# Final Determination on the Appropriateness of the Model Year 2022-2025 Light-Duty Vehicle Greenhouse Gas Emissions Standards under the Midterm Evaluation

## Response to Comments

U.S. Environmental Protection Agency  
Assessment and Standards Division

Figure 2-1 Most Cost-Effective Technology Packages Considered by EPA: Vehicle Type 1, Low Power-to-Weight, Low Road Load Vehicles (Small Car in Draft TAR) w/ I4 DOHC

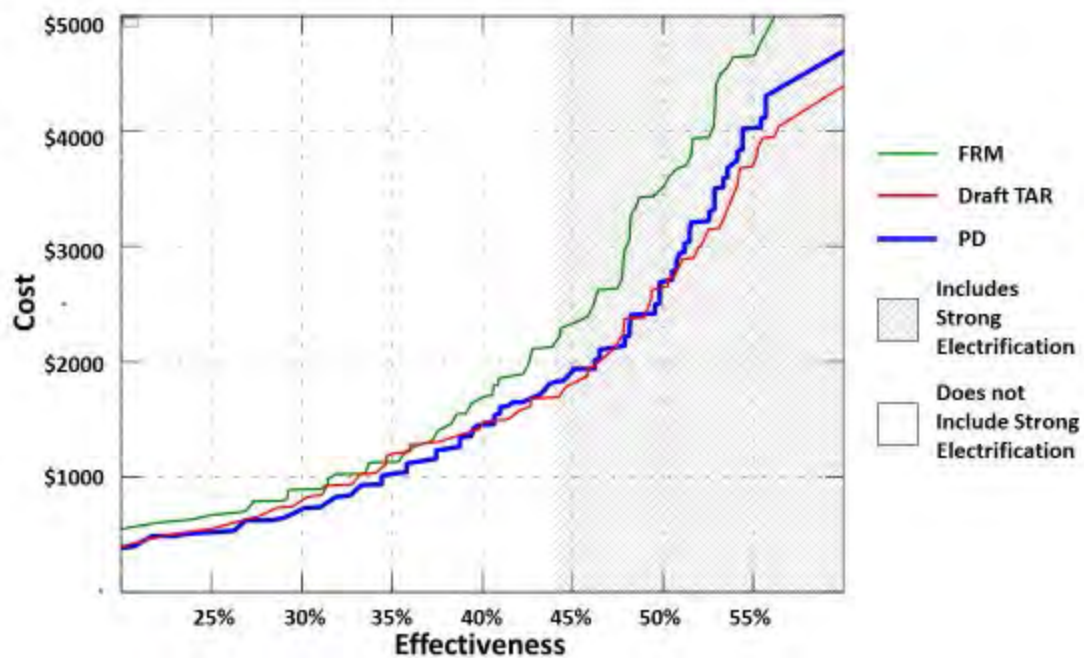
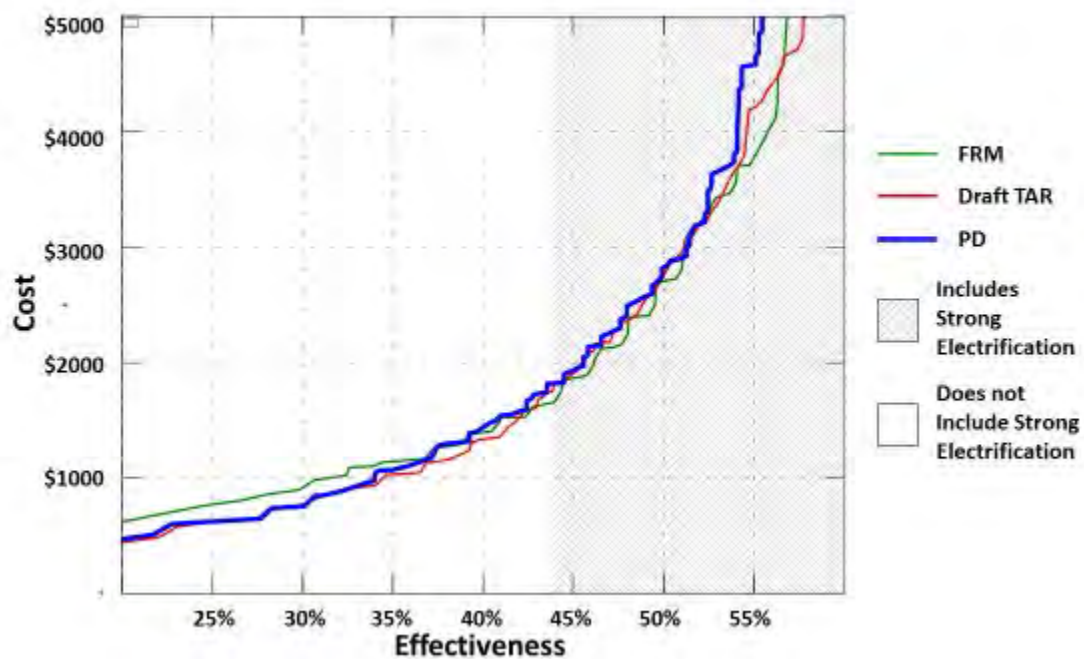
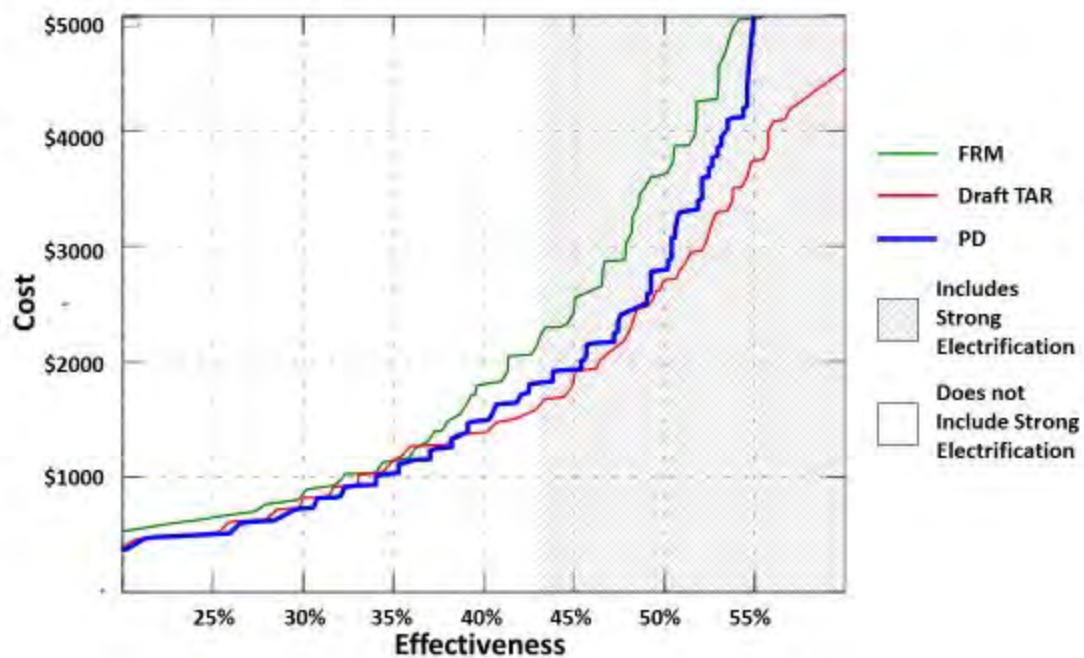
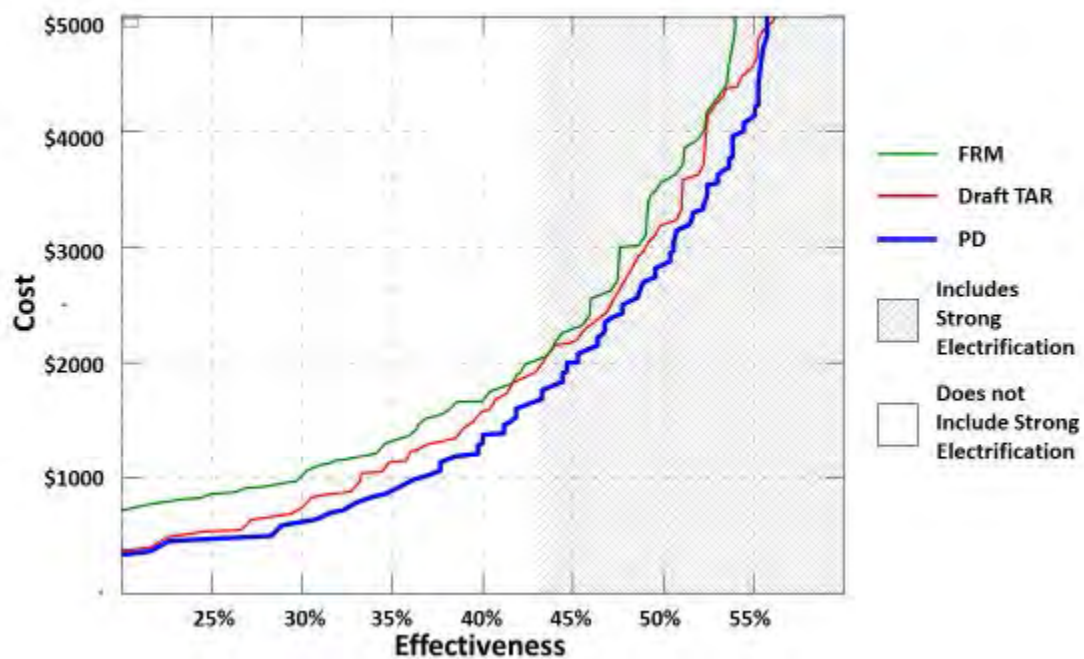
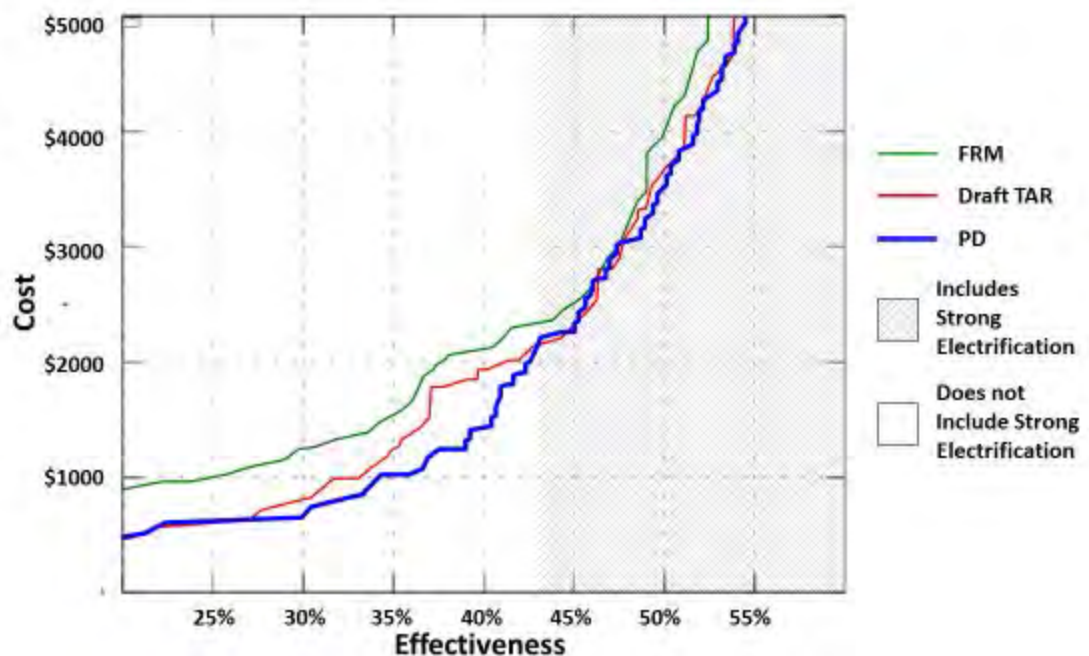
OEM commenters also aimed criticism at differences in projected penetrations of individual technologies between the Draft TAR and the 2012 FRM, characterizing these differences as evidence that the agencies' analysis approach was unsound. In response, EPA pointed out that these differences are not evidence of a flawed analysis but are a natural result of the Draft TAR having recognized and included innovations and improved efficiencies that occurred since the 2012 FRM, the very sorts of improvements that the Alliance contractor report assumed would not occur between now and 2025. See Proposed Determination at p. 24. In addition, the technologies reflected in the Draft TAR and Proposed Determination analyses reflect many of the technology changes that have been introduced in the fleet since the 2012 FRM. Thus, EPA would be remiss to not consider these technologies within the context of the MTE. The 2015 NAS report also recognized these important emerging and changing technologies, such as Atkinson cycle engines and CVTs, and recommended that the agencies consider these technologies in their future analyses. EPA thus disagreed that such differences in projected technology penetrations indicate in any way that the analysis and analytic approach were unsound. On the contrary, the incorporation of new technologies and unforeseen applications since the 2012 FRM would necessarily influence the cost-effective pathway modeled by EPA. *Id.* at p. 25. For example, the application of direct injection Atkinson cycle engines in non-hybrids, greater penetration of continuously variable transmissions (CVTs), and 48-volt mild hybridization have all influenced projected technology penetrations, as have developments in downsized turbo-charged engines, cylinder deactivation, and electrification. EPA also noted the consistently low level of strong electrification projected in the 2010 TAR, 2011 NPRM, 2012 FRM, and 2016 Draft TAR, as further corroborated by the 2015 National Academy of Sciences (NAS) study. This consistency has persisted even as EPA's technology assessment and compliance analysis has undergone many updates and improved in its precision over the past six years, further supporting EPA's determination that the MY2022-2025 standards remain appropriate. *Id.*

While the technology types considered and their projected penetrations have indeed changed over the time span between the 2012 FRM, Draft TAR, and Proposed Determination, these changes are largely due to the innovation of the automotive industry being reflected in our updated analyses. Furthermore, even as these technologies and penetrations have changed, the stability of EPA's estimated costs for complying with the standards support the conclusion that there are several viable cost-effective alternative pathways to meeting the MY2025 standards and that substantial levels of electrification will not be required. For example, transmission technology is one example of how competing technologies may evolve due to innovation to produce parallel options with little difference in cost or effectiveness. While the compliance costs will tend to be stable due to competition between multiple similarly cost-effective technologies, when a minor change in cost-effectiveness for one technology does occur (e.g., due to innovation), the projected penetration of the various competing technologies can change, in some case significantly. In the 2012 FRM, based in part on input from the auto industry and other stakeholders, EPA's assessment was that dual clutch transmissions (DCTs) would provide a better opportunity for significant improvements in vehicle efficiency than continuously variable transmissions (CVTs), due to indications that CVTs demonstrated characteristics that were unacceptable to U.S. consumers. However, since the 2012 FRM, it became clear that early implementations of DCTs were experiencing some consumer resistance, while CVTs were becoming well accepted in the market due to ongoing improvements (for example, improvements to control strategies, such as the implementation of indexed shifting to simulate the feel of a conventional automatic transmission). As a result, penetration of CVTs had become much greater than originally expected. In addition, improvements have been made in each type of automatic transmission such that the relative difference in efficiency between transmission architectures is rapidly diminishing. EPA believes that the changes reflected in each of EPA's analyses are the natural result of our representing in these analyses the continuing innovation in the light-duty market, and are not indicative of volatility, instability, or unsoundness as some commenters suggest.

Further, an examination of the cost-minimizing technology pathways also supports the stability of the assessments. Figure 2-1 through Figure 2-5 below show the curves that define the cost-minimizing technology package at each level of effectiveness ('frontier curves') for small car, standard car, cross-over utility, sport utility, and pickup truck vehicle classes. In these Figures, the technology cost-effectiveness estimated by EPA is shown to have generally improved in the Draft TAR and Proposed Determination (lowered frontier curves) relative to the FRM assessment, consistent with lower cost and/or higher effectiveness values that were identified in some cases by EPA when considering additional technologies and updated information in these most recent assessments. We note in these figures that conventional, non-electrified gasoline technology packages reside primarily in the region below 45 percent effectiveness, which is also the range of effectiveness values that will generally enable manufacturers to achieve the 2022-2025 standards. Within this critical range of effectiveness values, it can be seen that technology cost-effectiveness has remained within a narrow band between the Draft TAR and Proposed Determination – a finding that directly contradicts the commenter's assertion of "radical changes" that would call into question EPA's conclusions regarding the sufficiency of conventional non-electrified technologies. On the contrary, the consistency between the Draft TAR and Proposed Determination frontier curves shown in Figure 2-1 through Figure 2-5 is a direct indication of the general stability in EPA's modeling.

**Figure 2-6 Two Engine BSFC Maps, Reproduced in Technology Effectiveness – Phase II: Vehicle-Level Assessment**

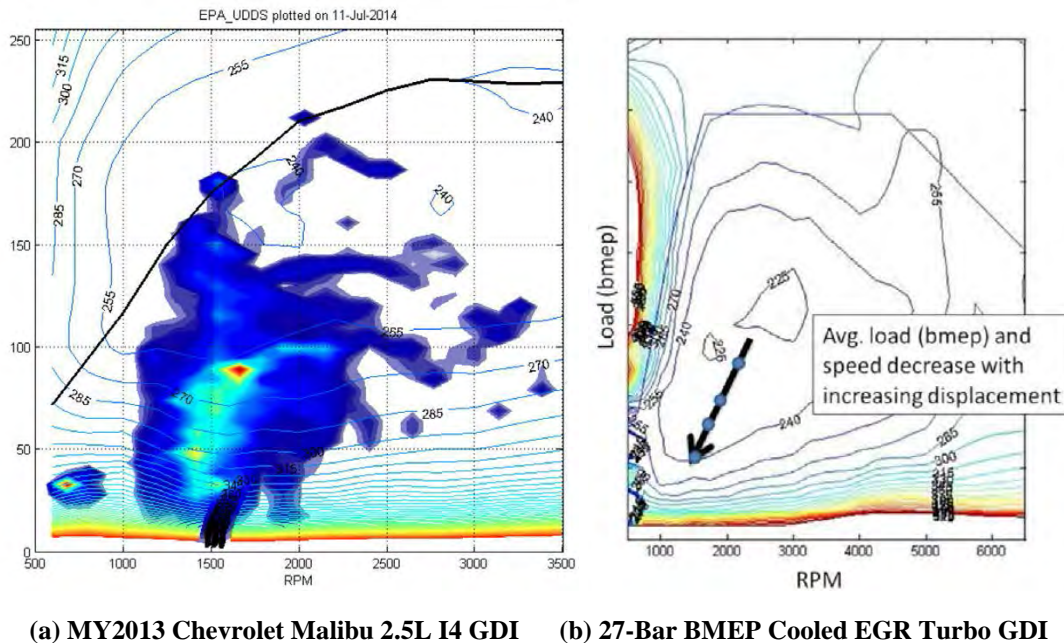
Novation in their comments further disagrees with EPA’s example of the overly restrictive nature of their plausibility checks by stating that EPA “relies on an illustrative example of an engine map that is not from an actual, tested engine.” In response, EPA agrees that this is an illustrative example, all the more so since the 27 bar map shown, and included in Novation’s original report, contains the overlaid arrow indicating how the area of greater efficiency is expended to the lower left, to better match the operating range of the engine during vehicle cycle operation. This is specifically illustrative of potential improvement in efficiency matching, and also illustrates UCS’ comment that lowering the on-cycle-to-peak engine efficiency ratio is precisely the objective of much of the research on conventional spark-ignition engines.

Novation continues in their comments, “[f]urthermore, the technology assumed from this map was not included in the TAR or the Proposed Determination.” Although this statement is something of a non sequitur, the 27 bar Ricardo map shown in Figure 2-6, and the underlying technology package, was indeed used to create 24 bar turbo downsized maps for the Draft TAR and the PD.

In the TSD Appendix A, EPA gave an example of the overly restrictive assumptions Novation uses, specifically using current engine technology to determine the limit of on-cycle-to-peak engine efficiency ratio (“Plausibility Test 2”). The example refers to two engine maps, a MY2013 Chevrolet Malibu 2.5L I4 GDI map and a 27-bar BMEP cooled EGR turbo GDI map (Figure 1.1 in the TSD Appendix A, and reproduced as Figure 2-6 in this RTC document). The 27-bar BMEP cooled EGR turbo GDI map has an enlarged area of high efficiency in the lower left (indicated by the arrow in Figure 2-6b). Since this is the area where engines tend to run over the cycle, the figure shows an example of how the application of engine technology can result in a better match between engine operation and peak efficiency. This reduces CO<sub>2</sub> emissions, precisely by increasing the on-cycle-to-peak engine efficiency ratio. A comment received from UCS agrees, stating in addition that “[l]owering this ratio is precisely the objective of much of the research on conventional spark-ignition engines.”

However, because the Novation report develops their plausibility limit for on-cycle-to-peak engine efficiency ratio based on a few MY2013-2014 vehicles, there is no room left below their arbitrary limit for the potential improvement in the efficiency matching shown in Figure 2-6. Put another way, the plausibility limit developed by Novation implicitly assumes that any potential improvements in engine technology which increase the efficiency of the engine while operating, relative to peak engine efficiency, are implausible.
